CITY OF LEWISTON
PLANNING BOARD MEETING
Monday, July 14, 2014 – 5:30 P.M.
City Council Chambers – First Floor
Lewiston City Building
27 Pine Street, Lewiston

TO: Planning Board
FROM: David Hediger, City Planner
DATE: July 10, 2014
RE: July 14, 2014 Planning Board Agenda Item IV(a)

An application submitted by Platz Associates on behalf of the Greater Androscoggin Humane Society to construct a new facility at 56 Strawberry Avenue.

TO: Platz Associates
FROM: David Hediger, City Planner
DATE: July 7, 2014
RE: Human Society, 56 Strawberry Ave

SHEET TITLE: **SITE DETAILS**

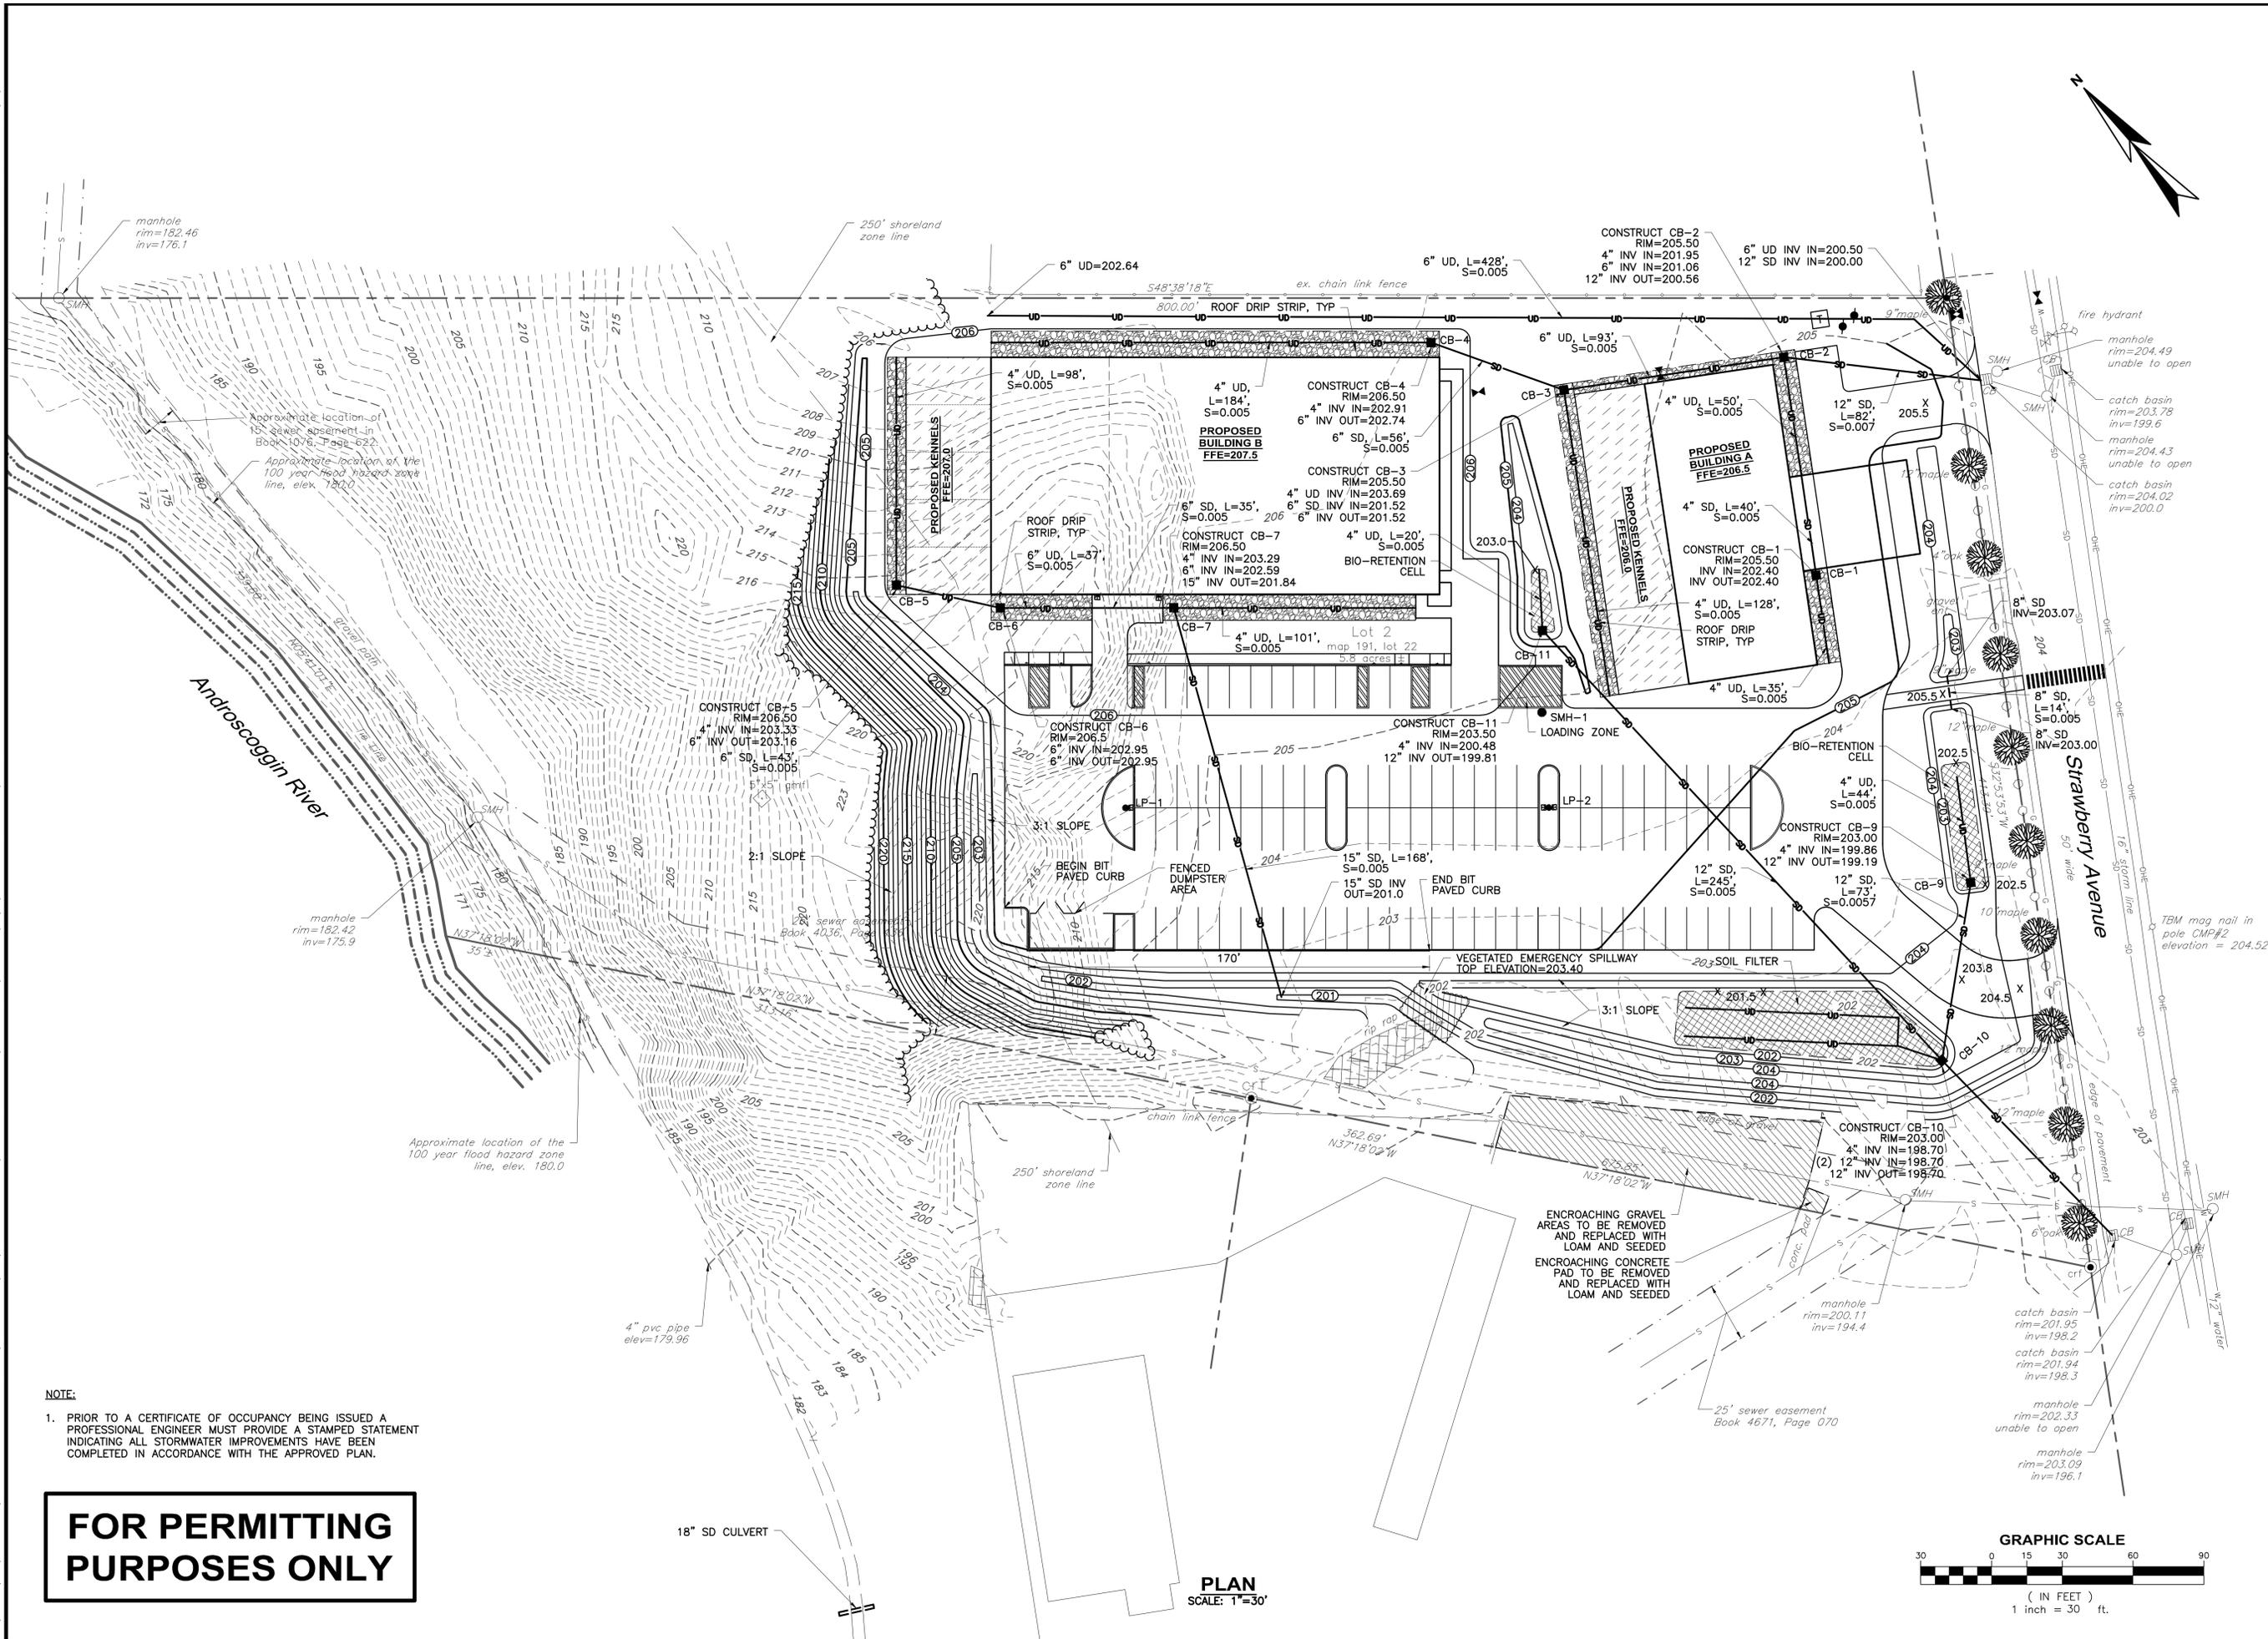
- C100 and 101: plan does not detail site lighting, light types, etc. Lighting must be full cut off fixtures. **Site lighting information now shown on C100 and C101.**

4. Sheet C100 – Appropriate signage shall be added to the northerly entrance indicating that it is enter only.
5. Sheet C101 – Detail 11 – ADA Ramps crossing Strawberry Avenue must have cast iron truncated dome panels placed in concrete.

6. Sheet C101 – Detail 1 – Asphalt build up in Strawberry Avenue shall be 3.0” of Hot Mix Asphalt 19.0mm and 1.5” of Hot Mix Asphalt 9.5mm.
7. Drawing C-1 – What is the purpose of the underdrain crossing the northerly portion of the site and entering the Cities Catchbasin?

DESIGNED BY: JWB	DATE:
CAD COORD: MRL	
CHECKED BY: JWB	ISSUED FOR PERMITTING: JWB 6/14
DATE: 7-10-14	RESPONSE TO COMMENTS: JWB 7/14
APPROVED BY: JWB	
DATE: 7-10-14	
PROJECT NO: 12978A

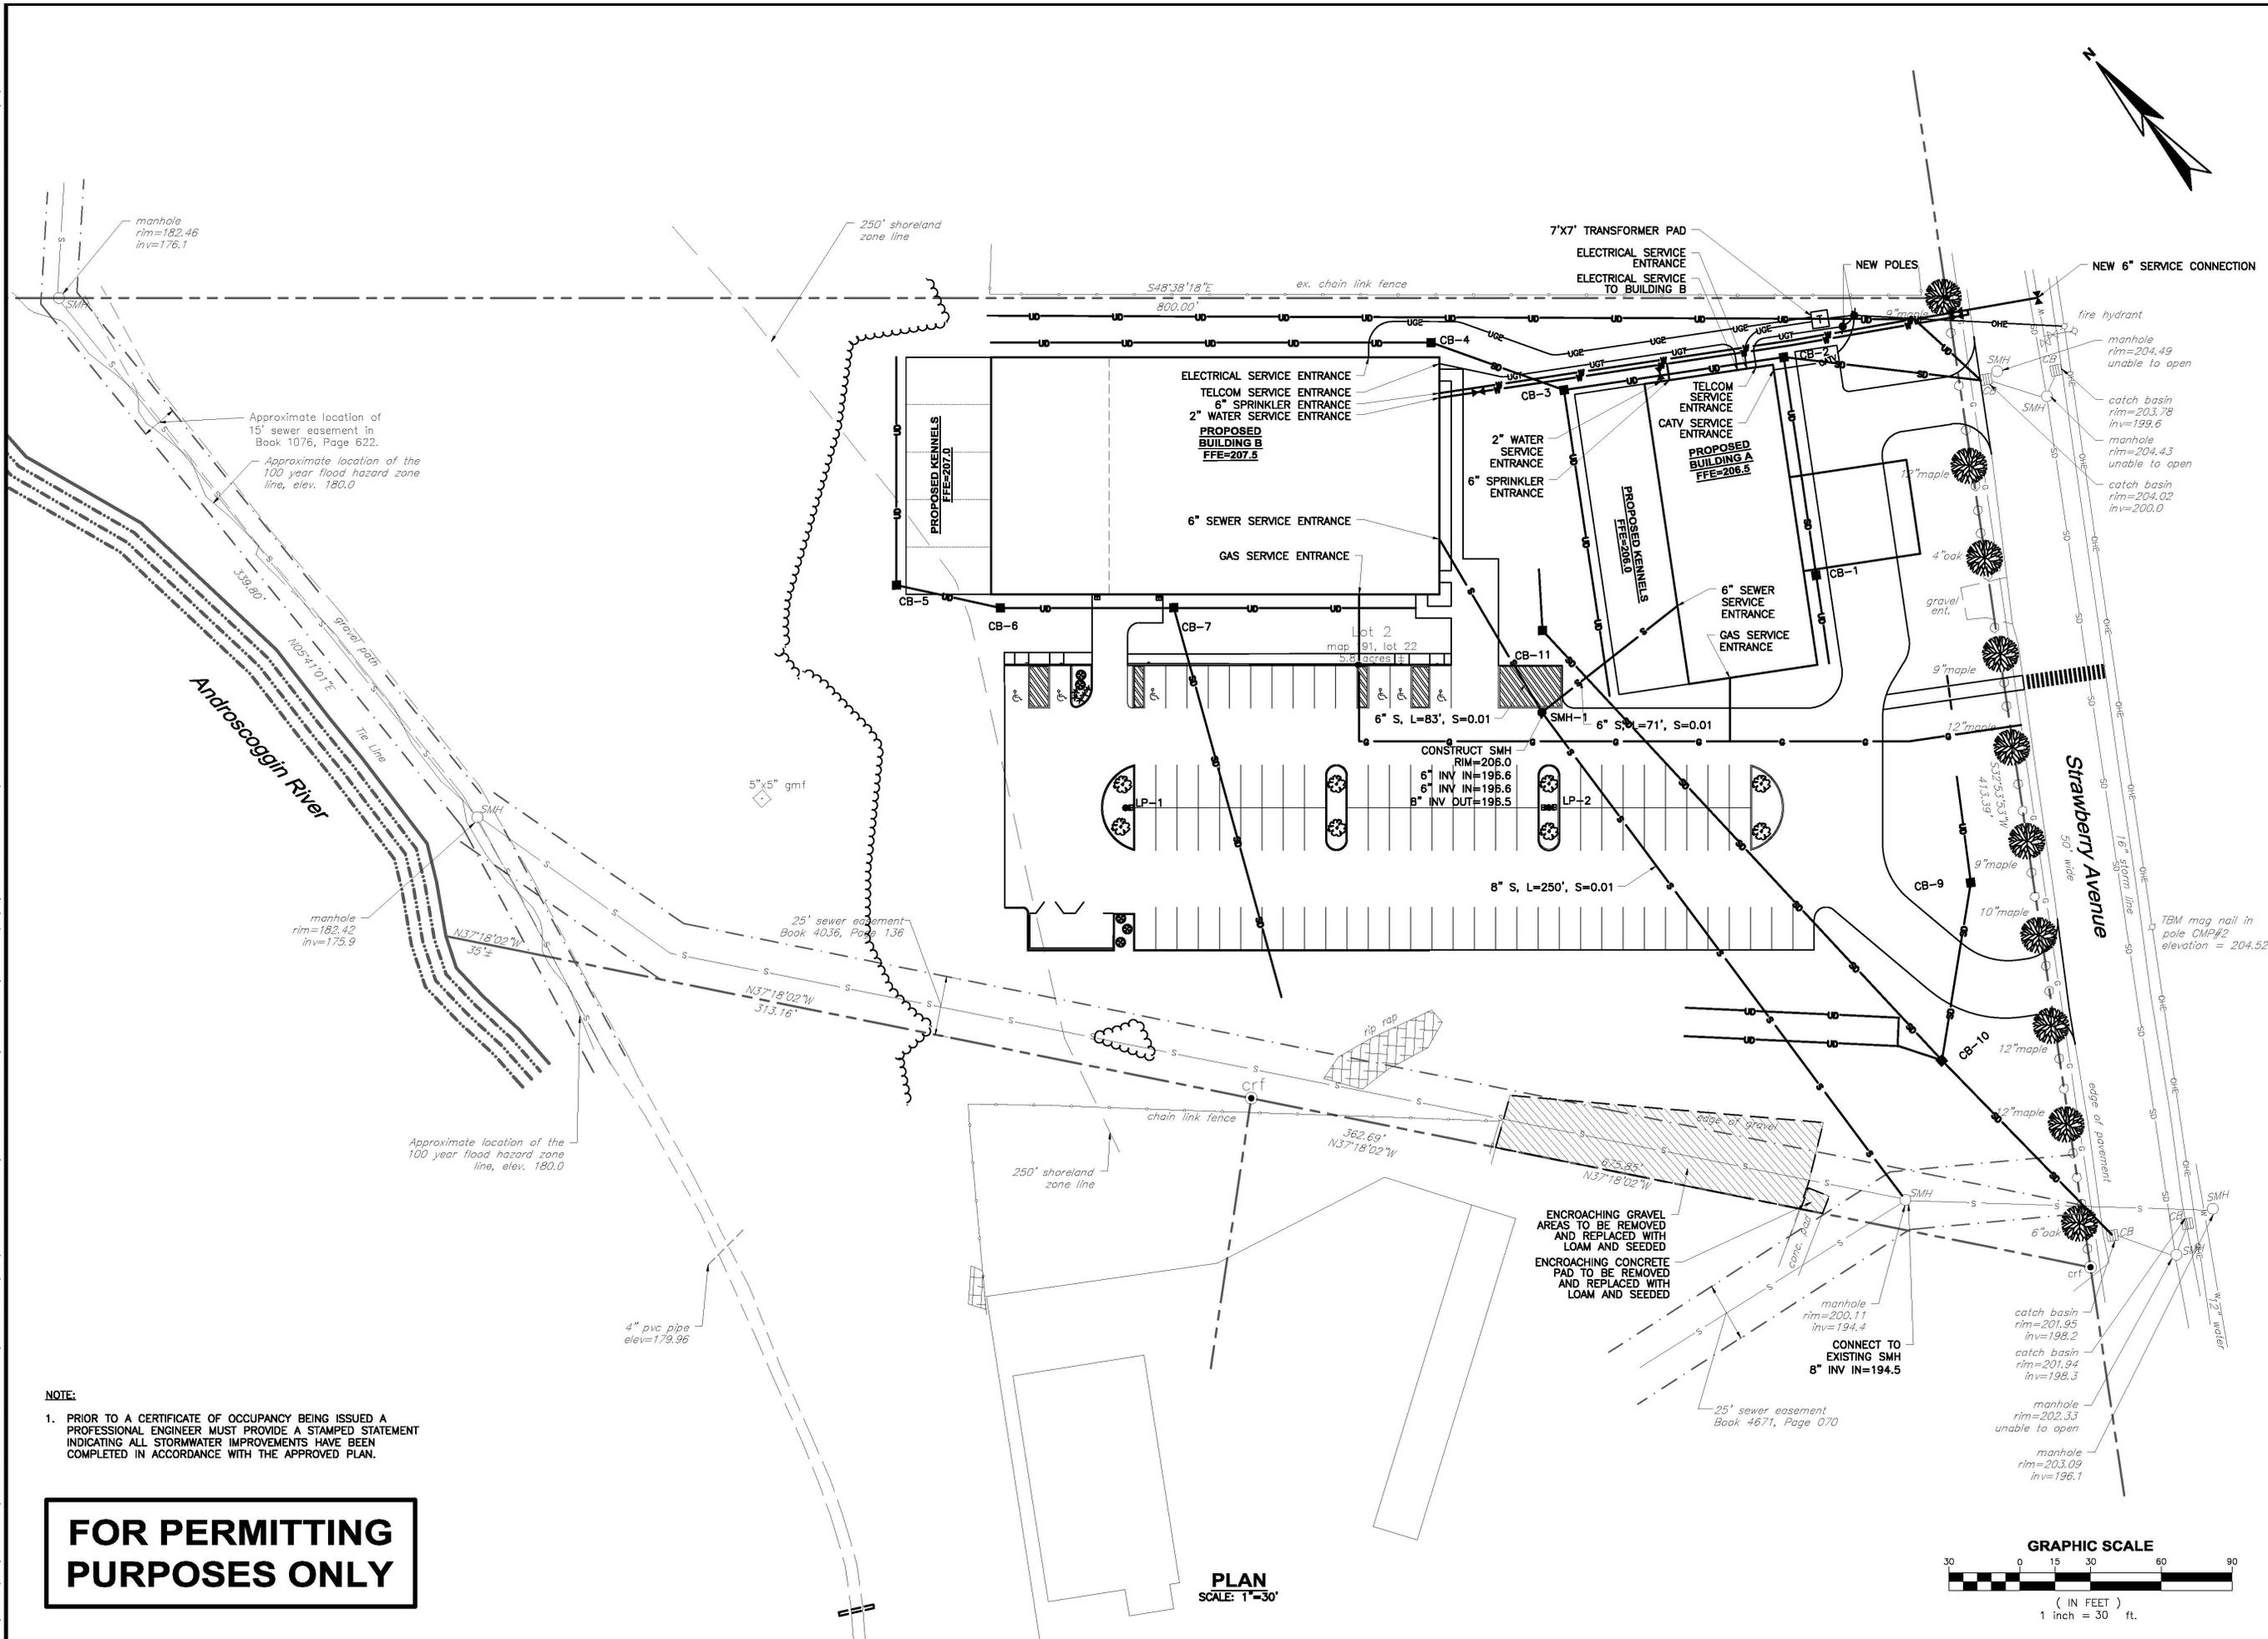
- Sheet C1 (and subsequent sheets): existing gravel and concrete pad at 52 Strawberry Ave appear to encroach onto the Humane Societies property. This yard violation appears to be the result the lots reconfiguration. Impervious areas must be removed, loamed and seeded. **C-1 and subsequent sheets now show the existing gravel area to be loamed and seeded and the concrete pad removed.**

- Sheet C1 (and subsequent sheets): should be amended to show raised landscaped islands as shown on Sheet C100. **These sheets have been amended to show the raised landscaped islands in the parking lot.**

- Sheet C1 should clearly define area/length of proposed bituminous curbing. **The beginning and end of the proposed bituminous curbing is now shown on C-1.**

- Prior to a certificate of occupancy being issued a professional engineer must provide a stamped statement indicating all stormwater improvements have been completed in accordance with the approved plan. A note to this effect should be added to the plans. **A**

note to this effect has been added to C-1.
